**SERVICE BULLETIN**

**NEW PERIMETER DOOR SEAL**

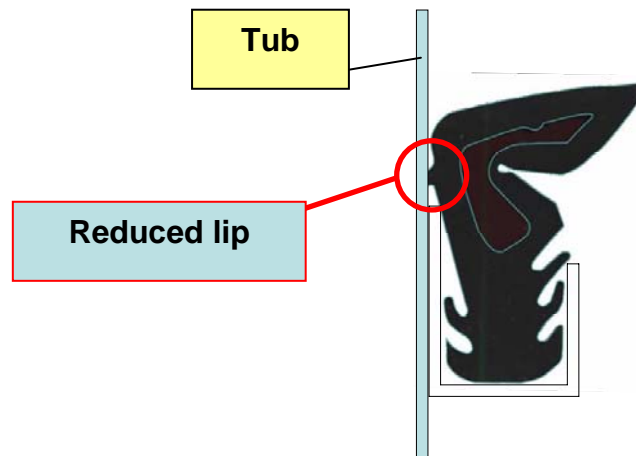
We inform you that new perimeter door seals will be introduced from March 2007 (Serial Number 710xxxxx) in the dishwashers produced in the Solaro factory.

The modification consists in the reduction of the lip that gets in contact with the tub wall (see drawing).

In case of servicing due to the interference between the upper basket rail and the perimeter door seal, use the new perimeter seal.

The new seals are perfectly interchangeable with the ones previously used.
